STATE OF NORTH CAROLINA
DEPARTMENT OF TRANSPORTATION

August 3, 2006

Subject: Application for Modification to Section 404, Section 401 permits and Neuse Buffer Certificate for the Knightdale Bypass-- US 64 from I-440 (Raleigh Beltline) to existing US 64 near SR 1003, I-440 from 0.83 mile south of US 64 to Poole Road and a portion of the East Wake Expressway from existing US 64 to the proposed US 64 Bypass in Wake County. State Project No. 8.142202, Federal Aid Project No. NHF-DPI-0199 (004), TIP No. R-2547 (Sections BA, BB, C and CC) and R-2641, \$475 Debit Work Order 8.142202, WBS Element 34455.1.7.

The purpose of this submittal is to request a modification to the Section 404 permit and the Section 401 Water Quality Certificate/Neuse Buffer Certification, specifically for the stormwater/hydraulic design at several sites. All of the issues on Section BB, C and CC involve the installation of additional riprap to provide stability to problem areas on the site. The following is a description of the modification that is proposed at each site.

N. C. DEPT. OF TRANSPORTATION
 DIVISION OF HIGHWAYS
 WAKE COUNTY
 PROJECT: 8.1.402202 (R-2547BB)
 US 64 BYPASS FROM NEW HOPE
 ROAD TO EAST OF SR 2601
 CLIFTON ROAD
 SHEET 23 OF 30 REV 6/28/06

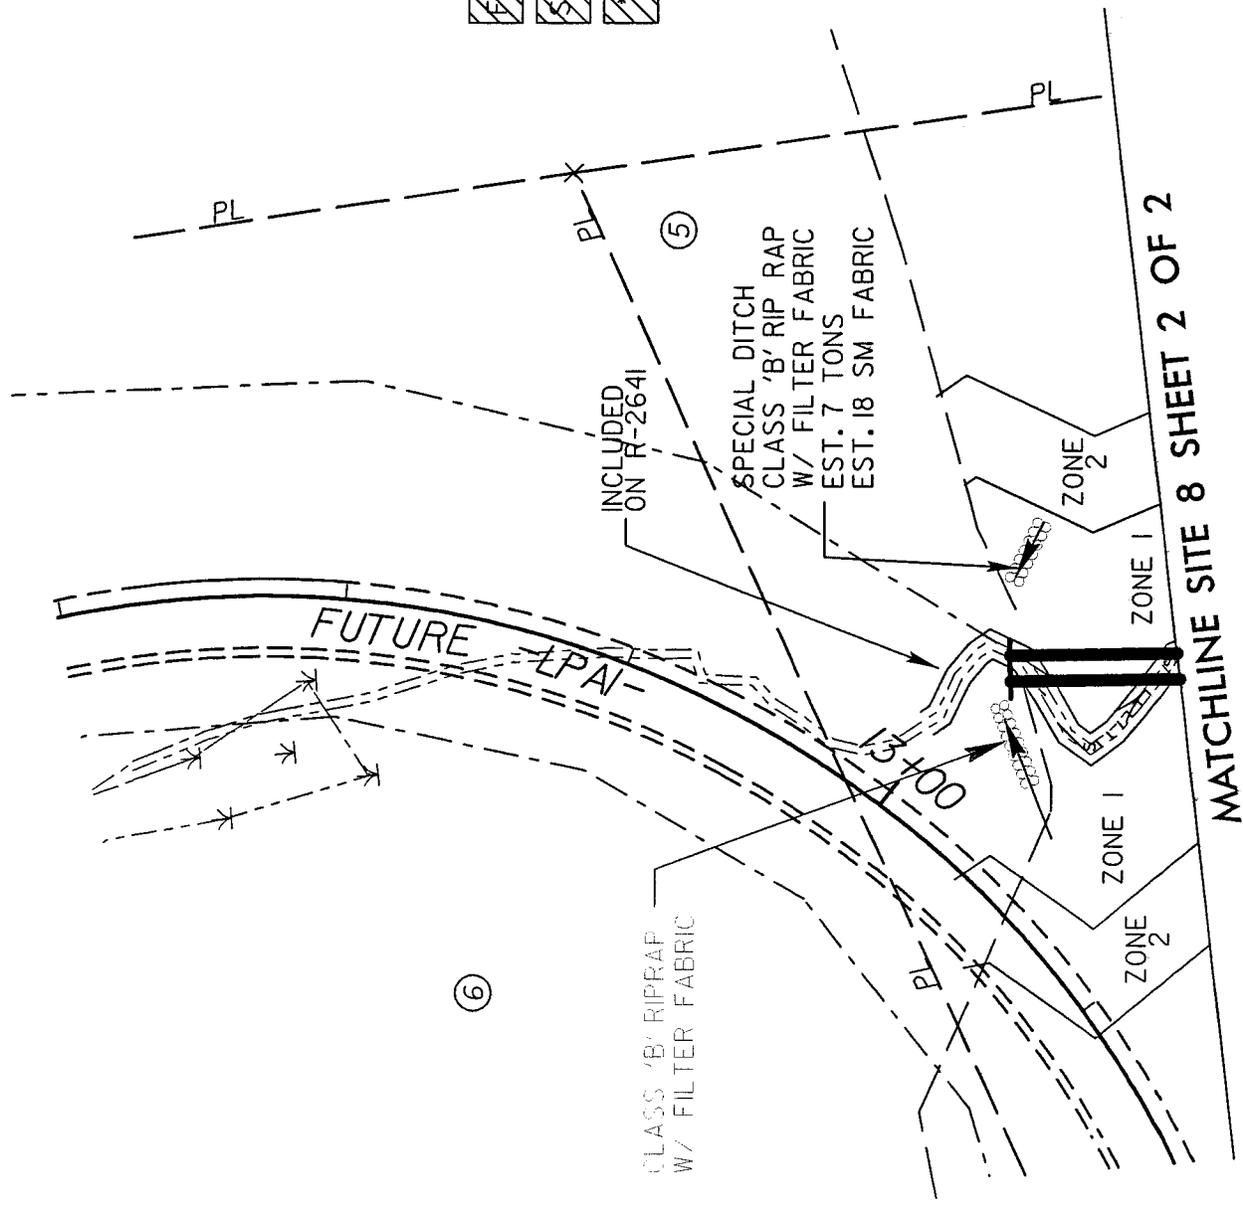
Site 8A Section BB (Revised Permit Drawing 23 of 30 dated 6/28/06) and Construction Plan Sheet 14C

Issue: Class 'B' riprap has been added to the cut ditch where the ditch ties to the stream to provide stability.

Resolution: The added riprap permanently stabilizes the area and eliminates erosion problems at the site.

No additional impacts occur as a result of this change as the riprap is located within the previously permitted buffer area.

N. C. DEPT. OF TRANSPORTATION
DIVISION OF HIGHWAYS
WAKE COUNTY
PROJECT: 8.1402202 (R-2547CC)
US64 FROM SR2502 TO EXISTING
US64 NEAR SR1003
SHEET 7 OF 24 REV 6/28/06

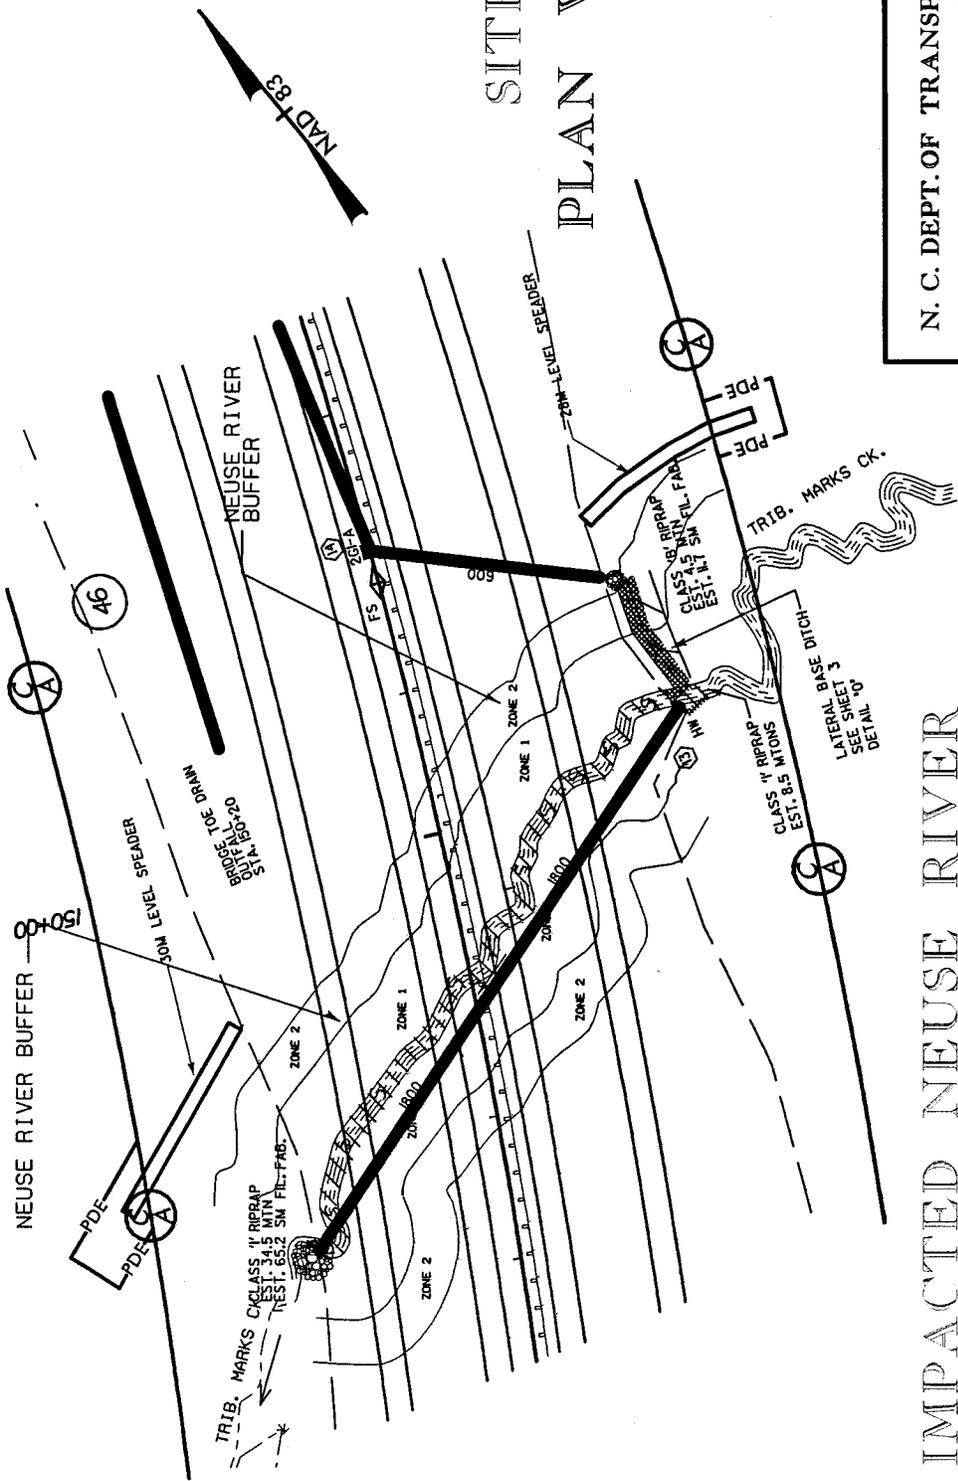
Site 3 Section CC (Permit Drawings 6 and 7 of 24 dated 6/28/06) and Construction Plan Sheet 6

Issue: Riprap has been installed in the base ditch and at the junction with the stream channel.

Resolution: Riprap has been installed on the bank to provide permanent stabilization so that a head cut does not occur.

No additional impacts occur within the riparian buffer as this riprap is located within area of previously permitted impacts.

SHEET 12 OF 24 REV 6/28/06

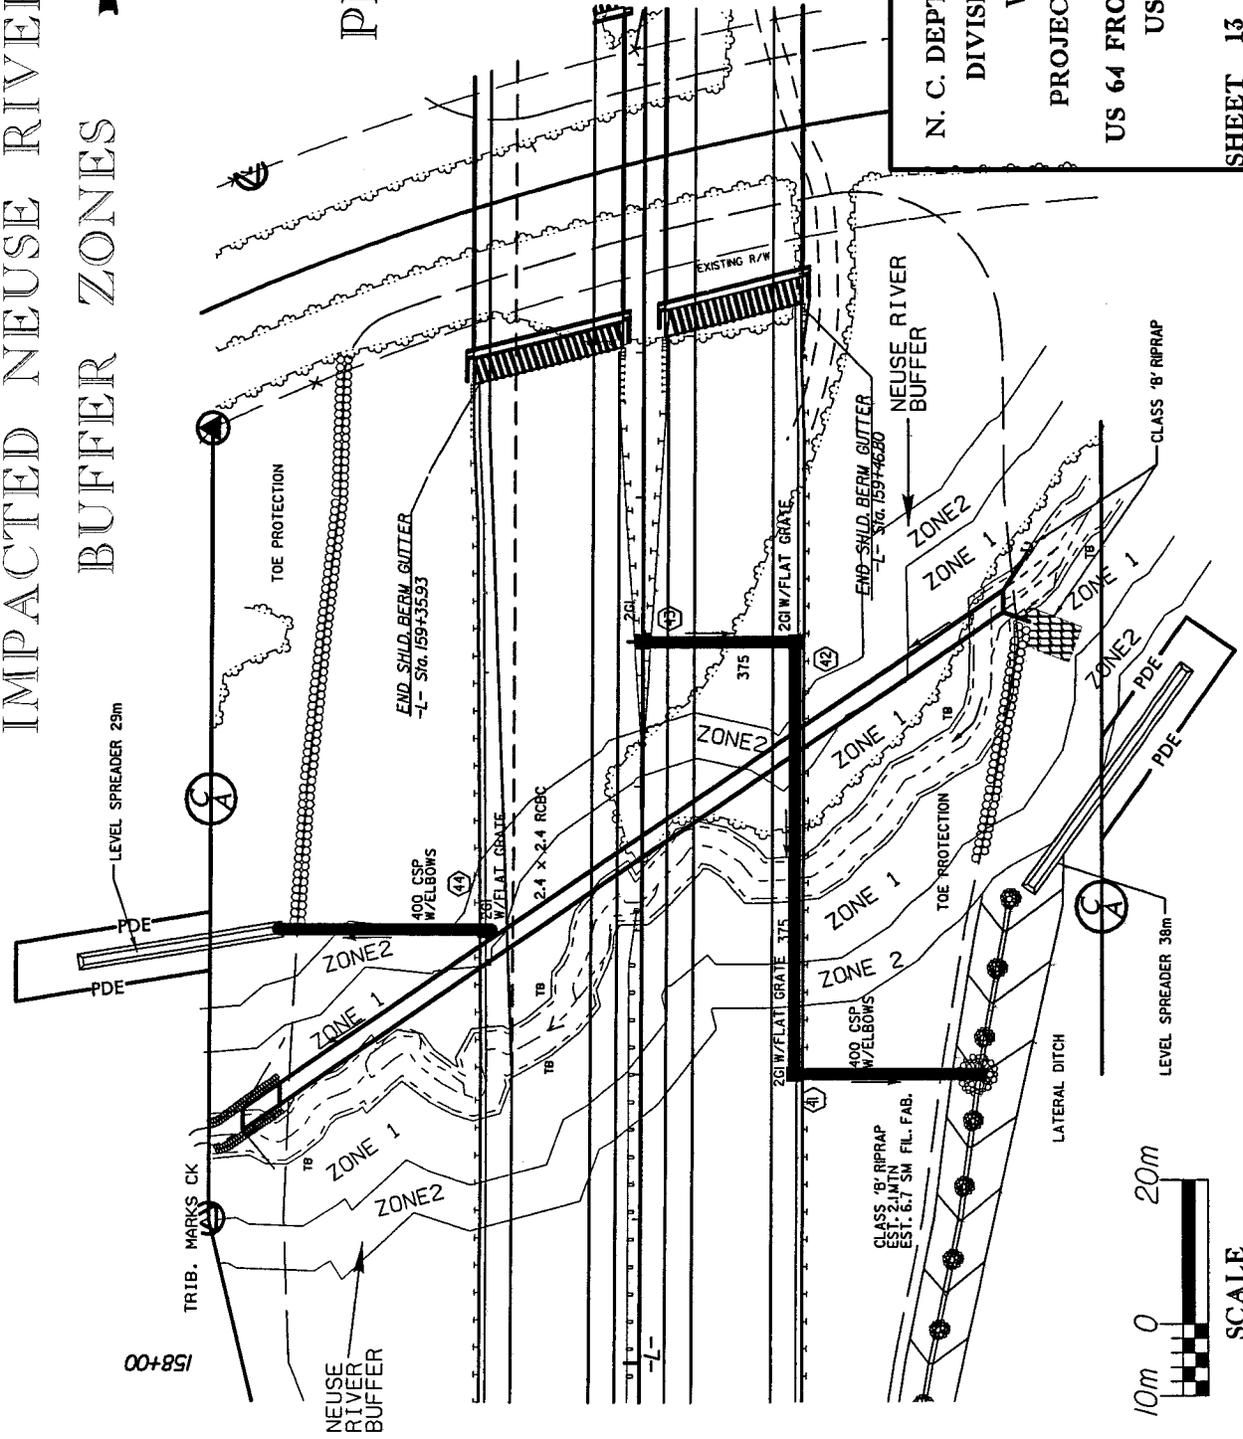
Site 6 Section CC (Permit Drawings 12 and 13 of 24 dated 6/28/06) and Construction Plan Sheet 8

Issue: Instability on the south stream bank has been a reoccurring problem at the culvert inlet.

Resolution: Riprap has been installed along the streambank and within the riparian buffer to provide long-term stability.

No additional impacts occur within the riparian buffer and along the steambank as this riprap is located within the previously permitted impact footprint.

SHEET 17 OF 24 REV 6/28/06

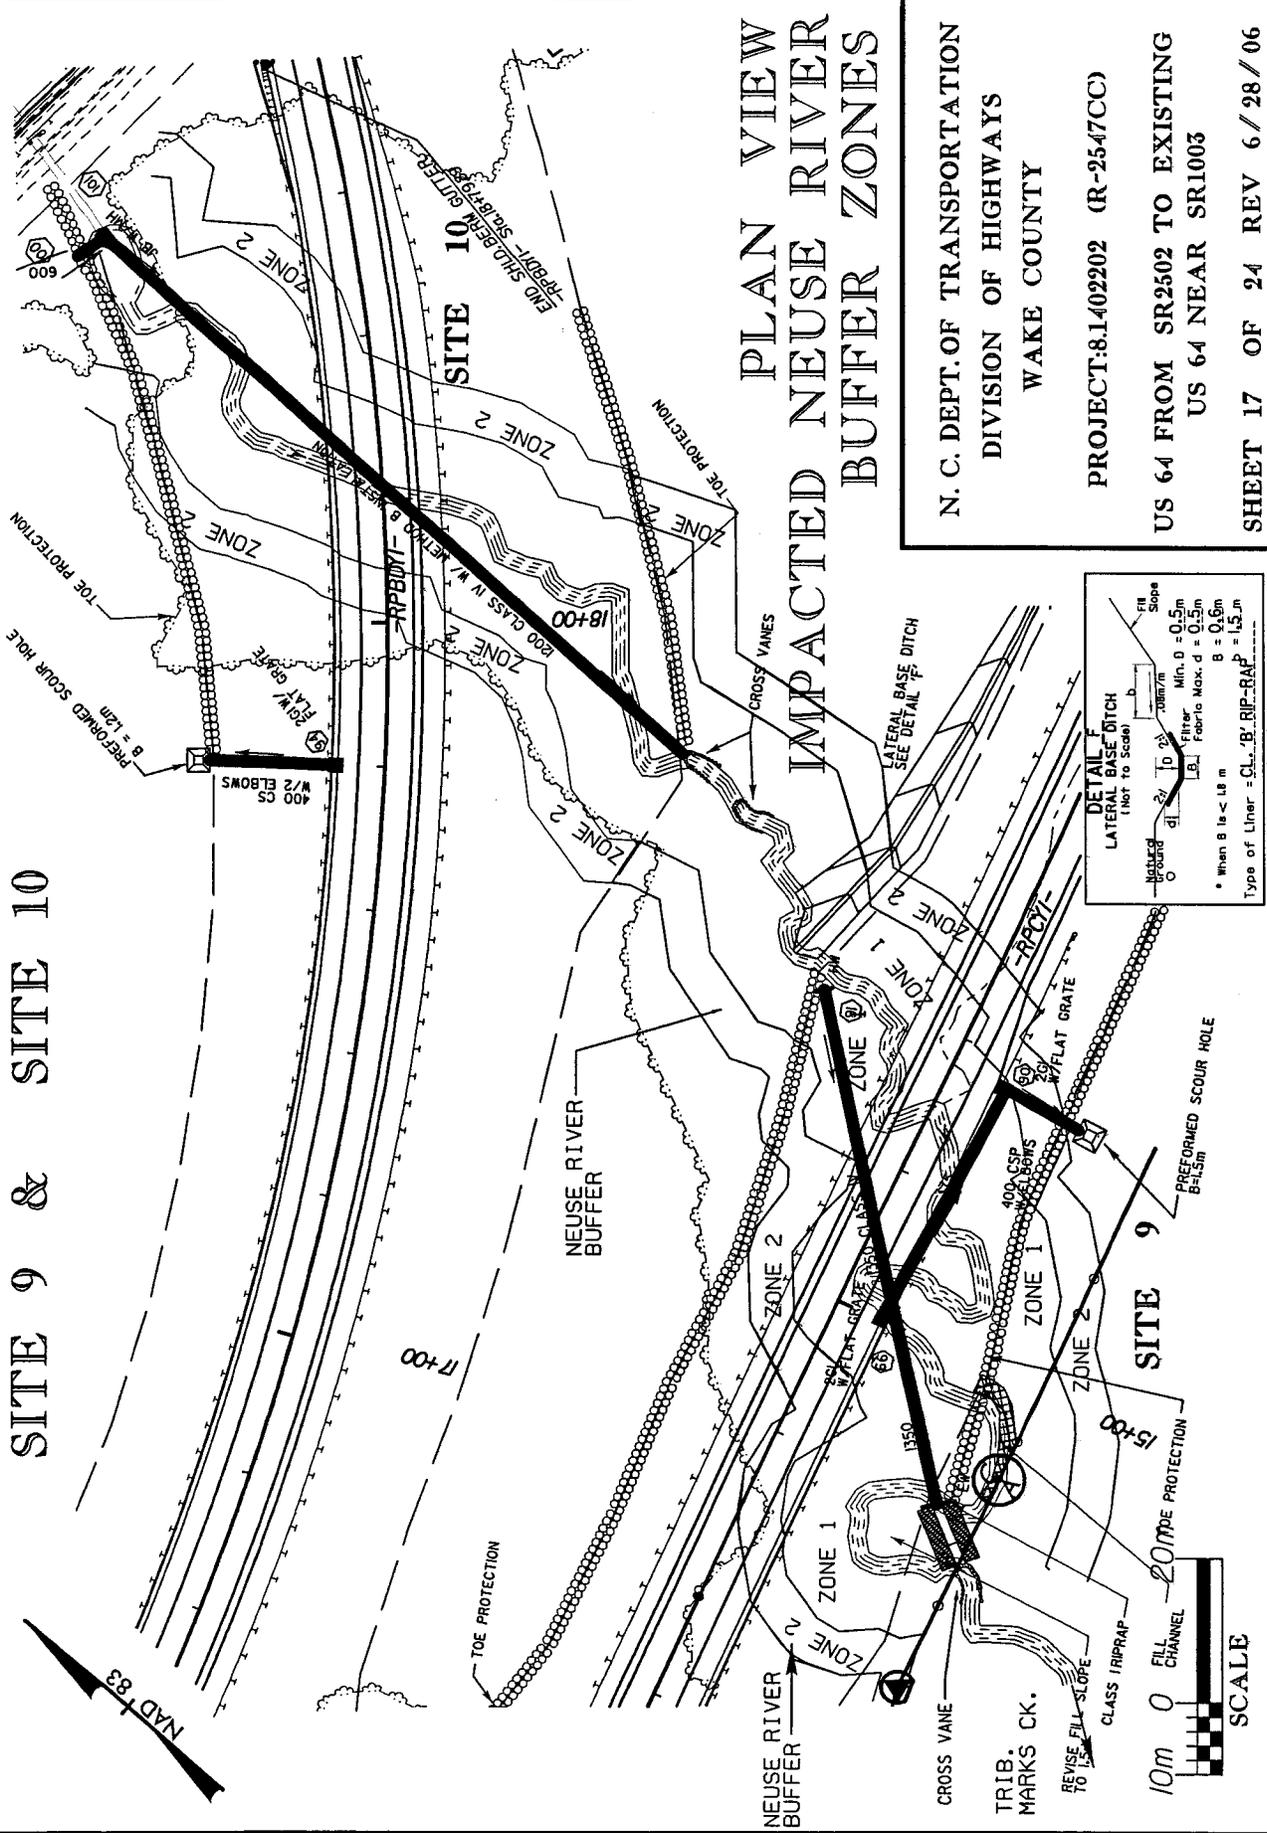
Site 9 Section CC (Permit Drawings 16 and 17 of 24 dated 6/28/06) and Construction Plan Sheet 10D

Issue: Channel bank stability at the outlet of the 1350mm RCP has been a problem.

Resolution: Riprap has been installed on the bank to provide permanent stabilization in the area of the new channel, but does not extend past the cross vane.

No additional impacts occur within the riparian buffer and at the stream as this riprap is located within the area of previously permitted impacts.
